12 May 2009

RE: Final Focused Feasibility Study Report
Greif, Inc. Facility
Town of Tonawanda, Erie County, New York
NYSDEC VCP Number V00334-9

Environmental Resources Management (ERM), on behalf of Sonoco Products Company (Sonoco), reviewed the conditional approval correspondence dated 4 August 2008 from the New York State Department of Environmental Conservation (NYSDEC) containing comments derived from NYSDEC and New York State Department of Health (NYSDOH) review of the Draft Focused Feasibility Study (FFS) Report for the Site dated June 2007. ERM, on behalf of Sonoco, offers the following response to NYSDEC and NYSDOH comments. To facilitate your review, regulatory comments are reiterated below in italic font followed by our response in bold font.

**Figure 1-13 - Summary of Fluid Recovery
 DNAPL Recovery Interim Remedial Measure
 Greif Facility – Tonawanda, New York
 NYSDEC VCP Number V00334-9
 ERM Project Number 0051923**

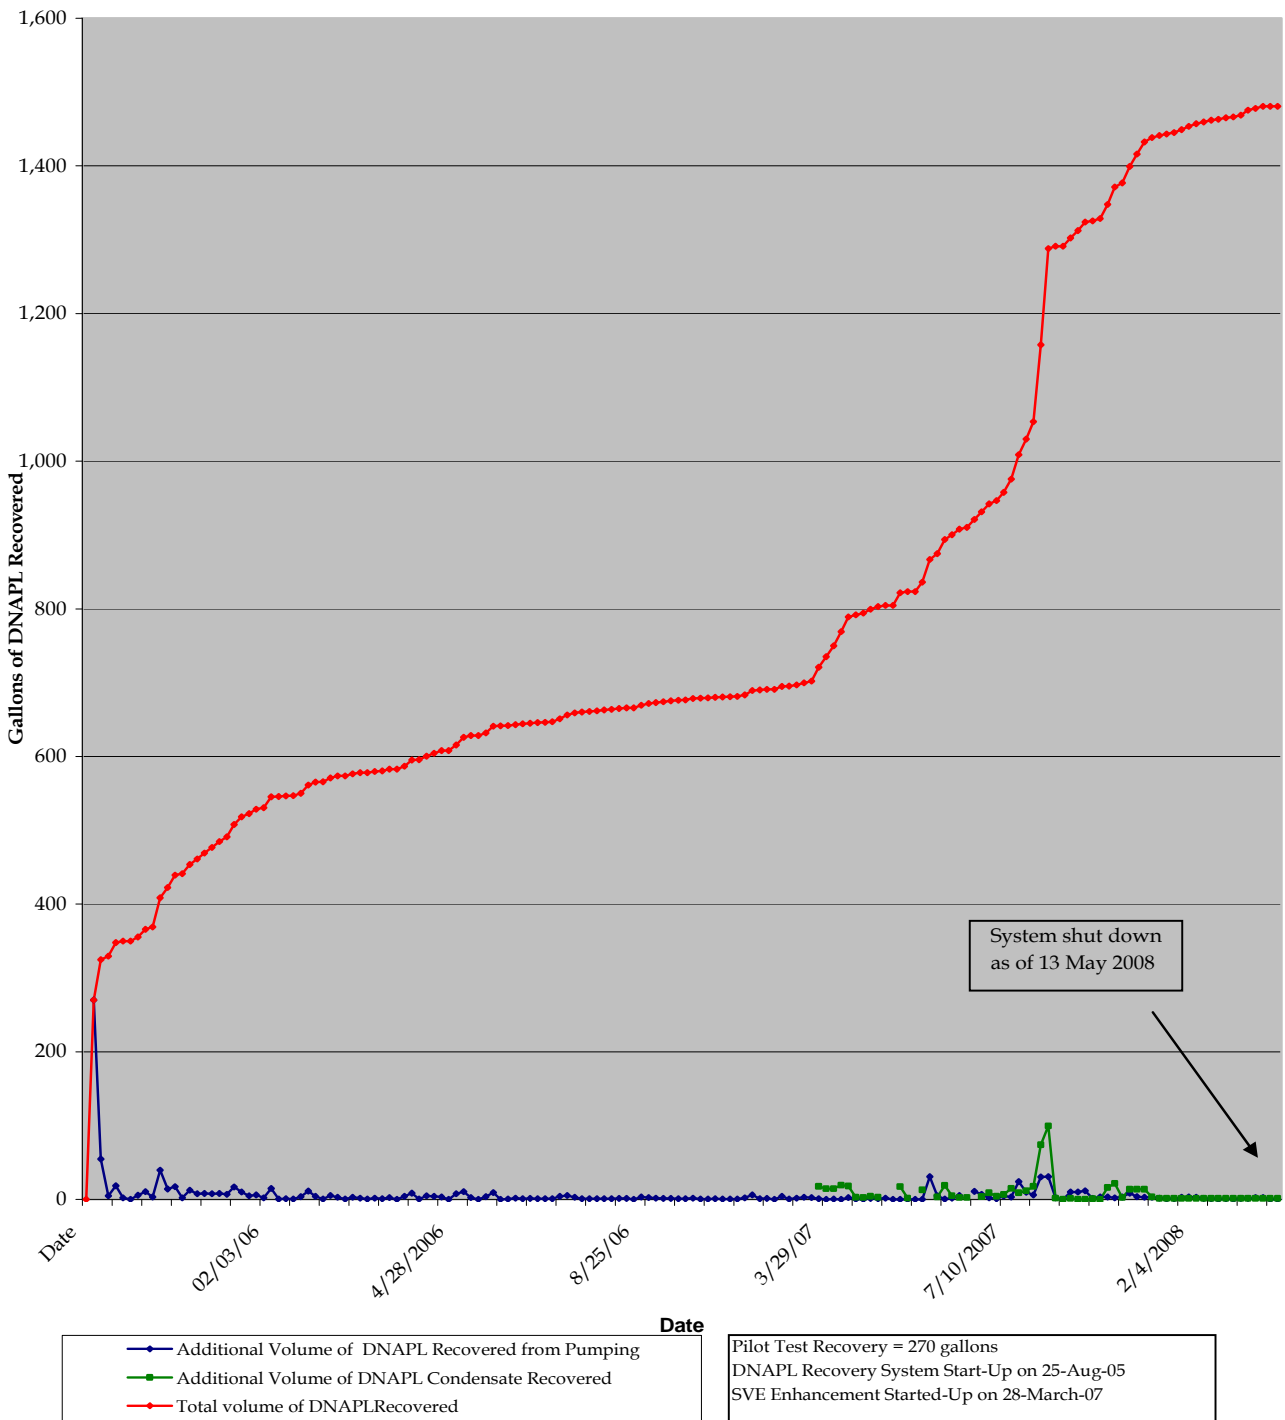
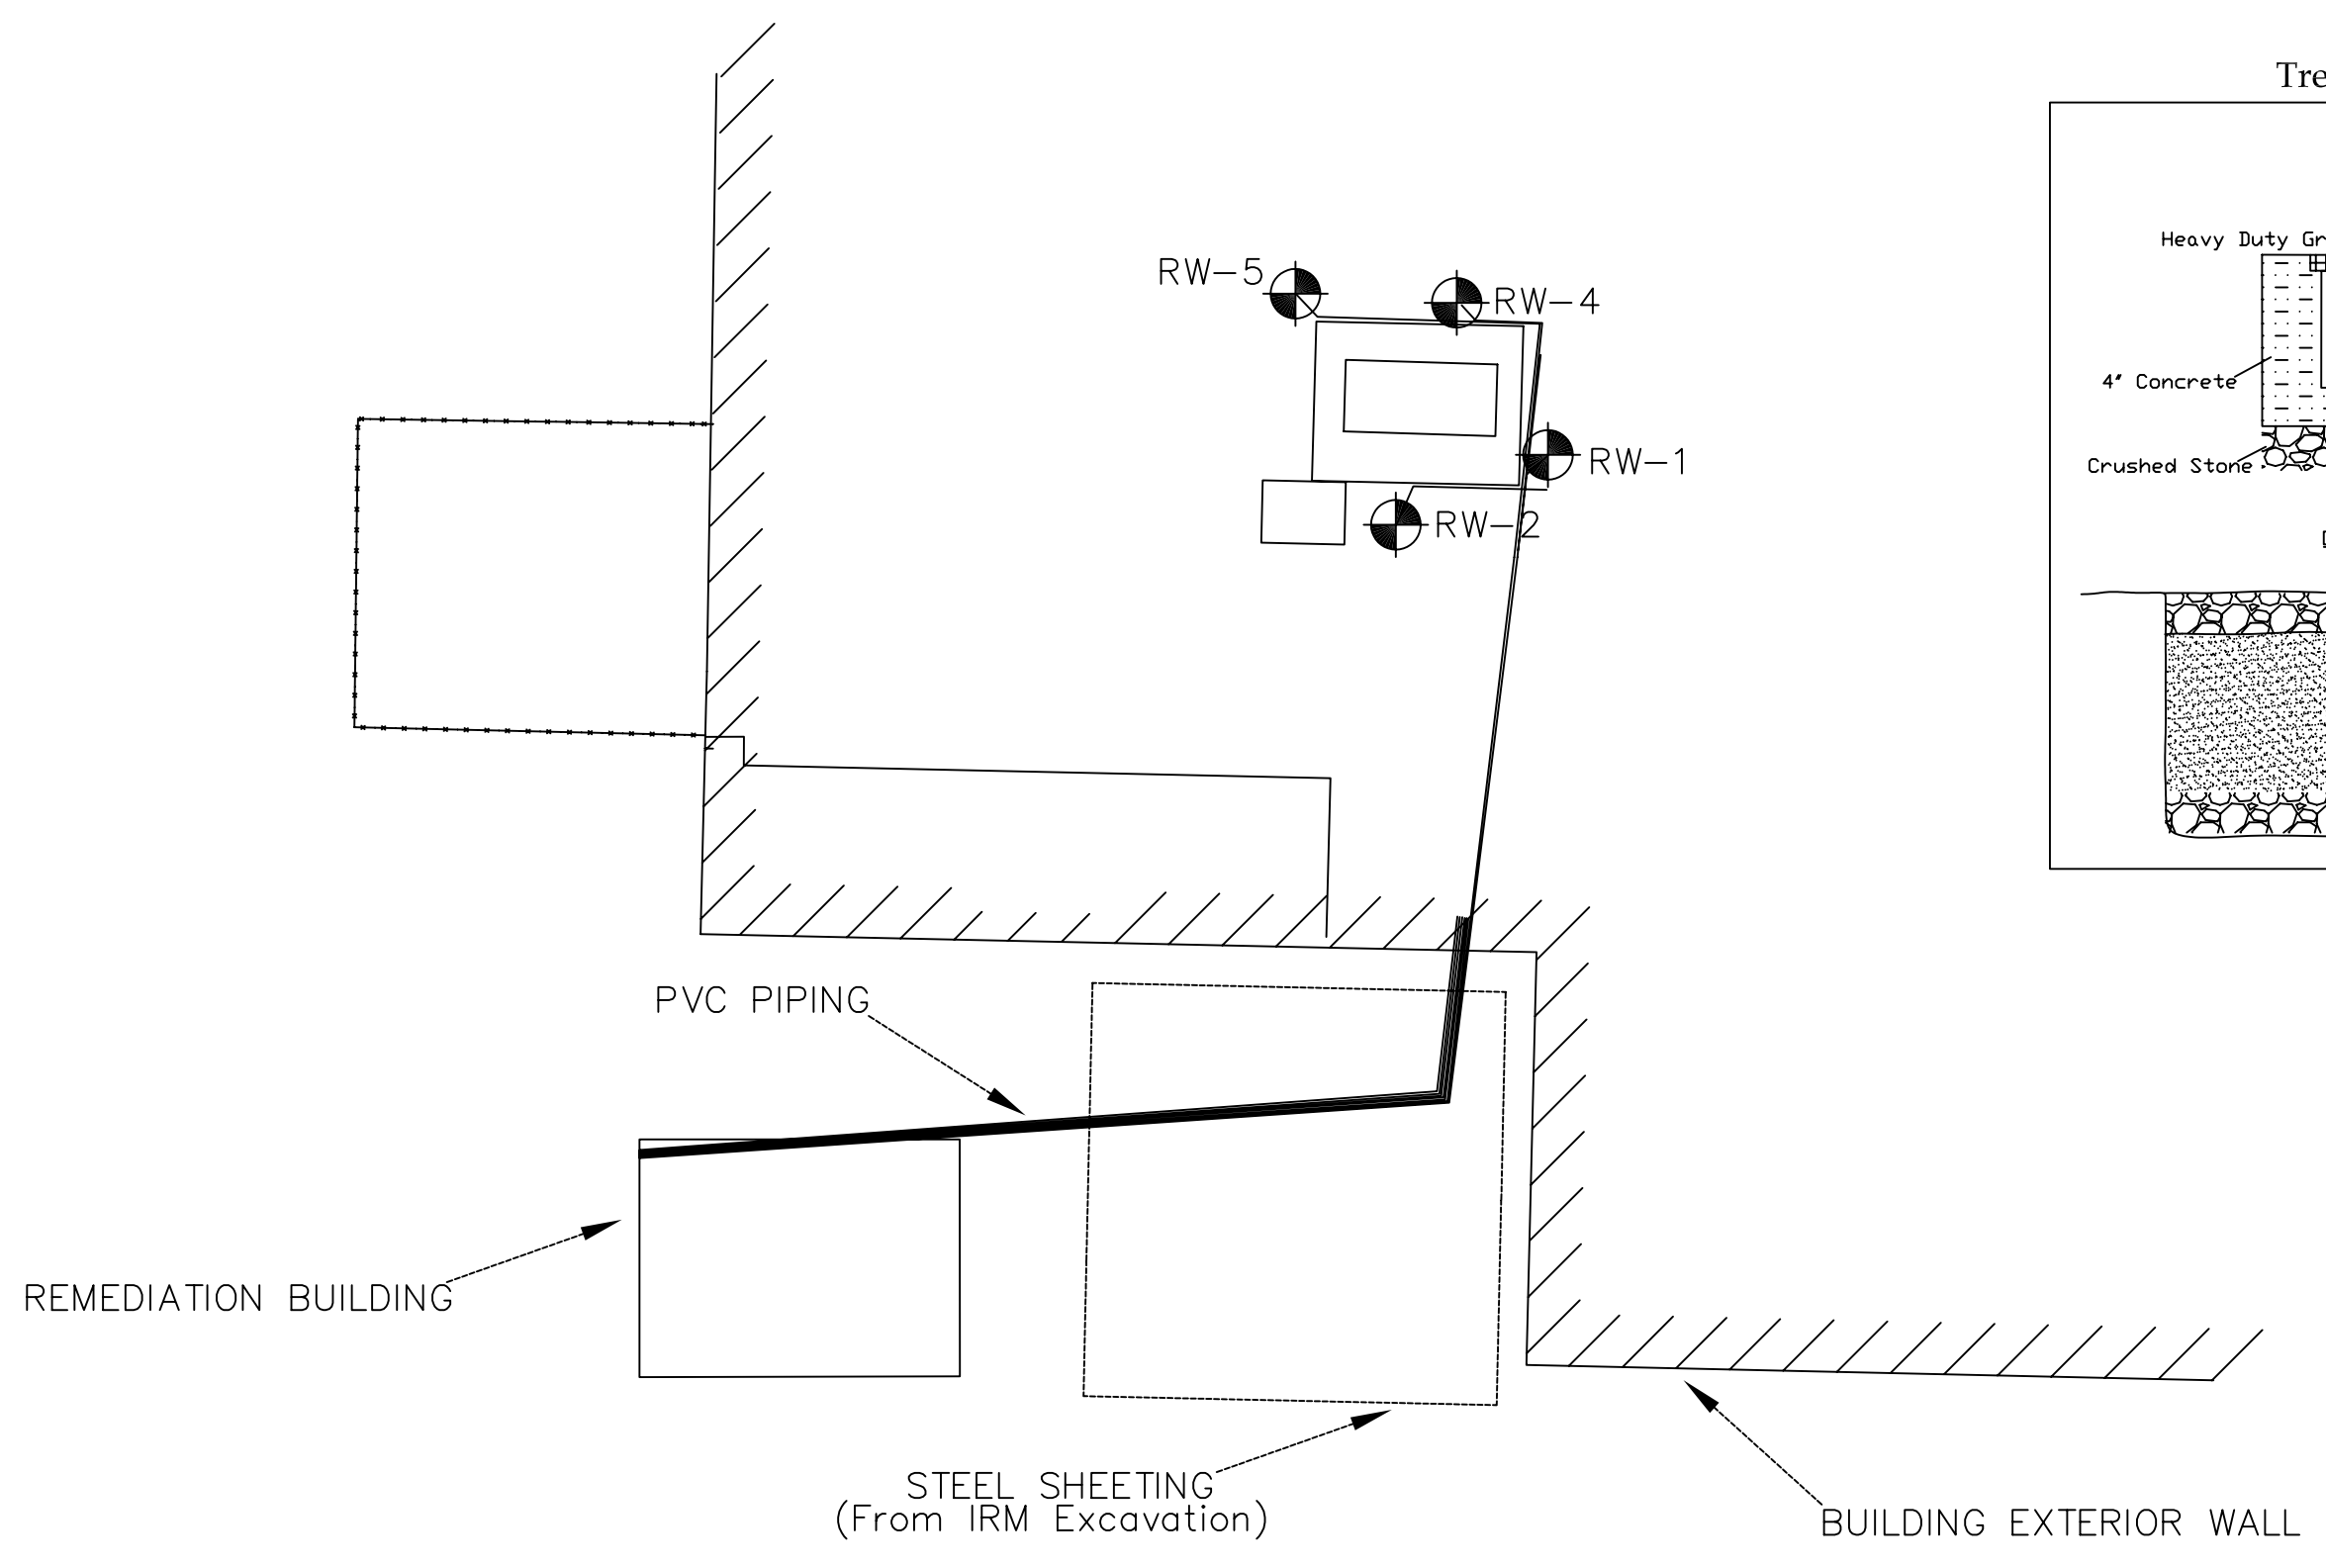
2. *Section 1.5.2.1 DNAPL Recovery System and Section 1.5.2.2 Low Vacuum Enhancement of DNAPL Recovery System IRM – Please update these sections to reflect the current site conditions;*

These sections of the report text as well as FFS Report Table 1 and Figure 1-13 have been updated as requested to provide additional data collected since the initial submission of the FFS Report in June 2007 through shut-down of the DNAPL recovery system in May 2008.
